# 2016 Corvette: Service Bulletin: Delayed Engagement After Sitting With Engine Off

## #16-NA-014: Delayed Engagement After Sitting With Engine Off - (Jan 21, 2016)

**Subject:** Delayed Engagement After Sitting With Engine Off

- (A) Old stator support asm 242  
74636/24275106/2427265  
6
- (B) New stator support asm  
24277234

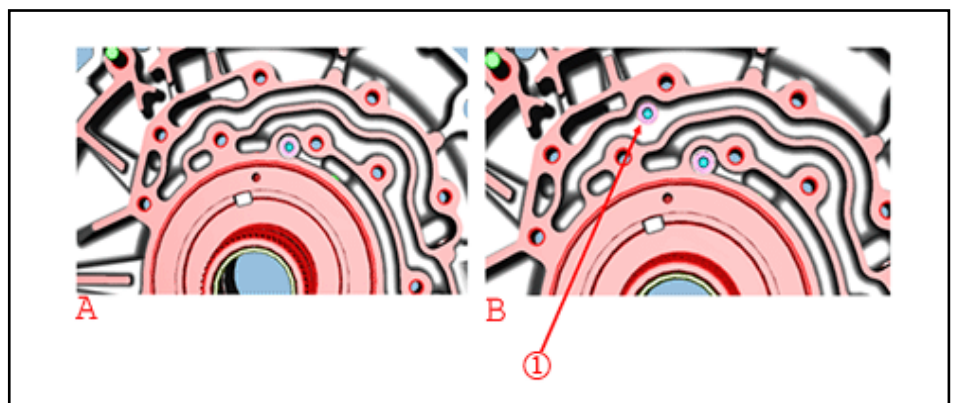
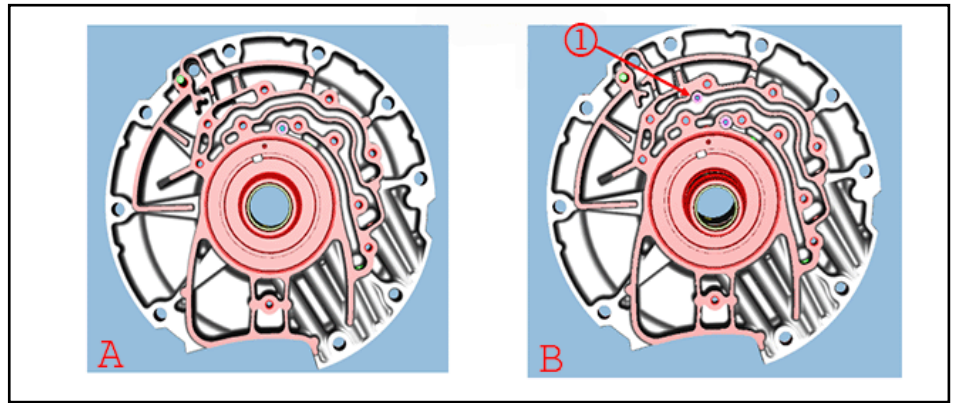
**Note:** The new stator shaft support assembly has a second check ball (1) added (see illustrations).

Install a new stator shaft support assembly that includes an additional check ball. Follow the instructions below to replace the stator shaft support assembly.

Old cover 24272660

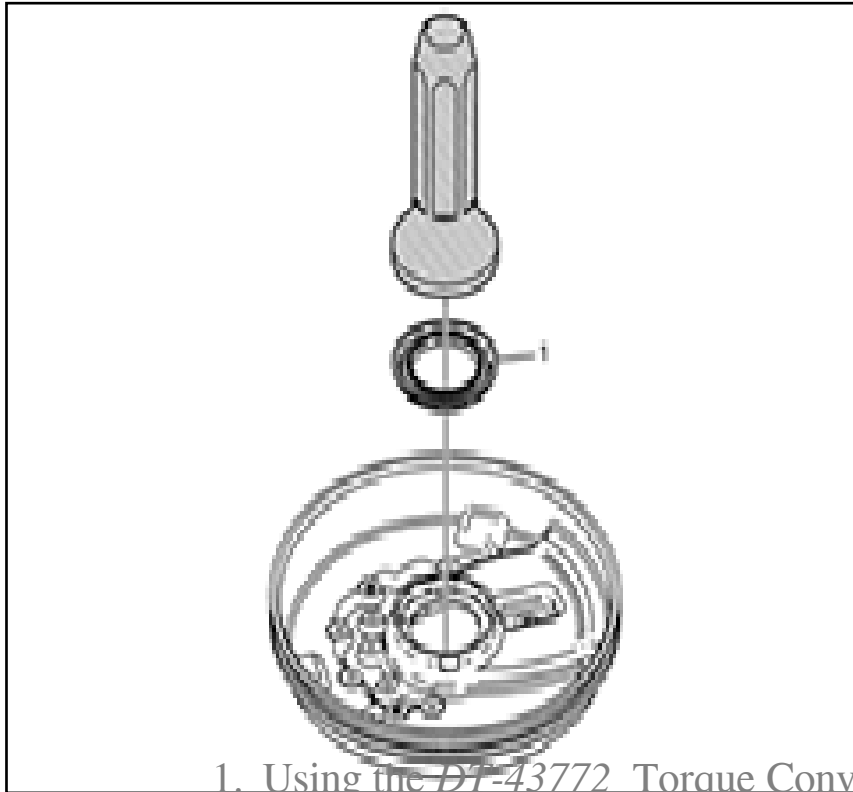
(A)

(B)

New cover 24277964

**Note:** The casting void has been eliminated from the underside of the cover (see illustration).
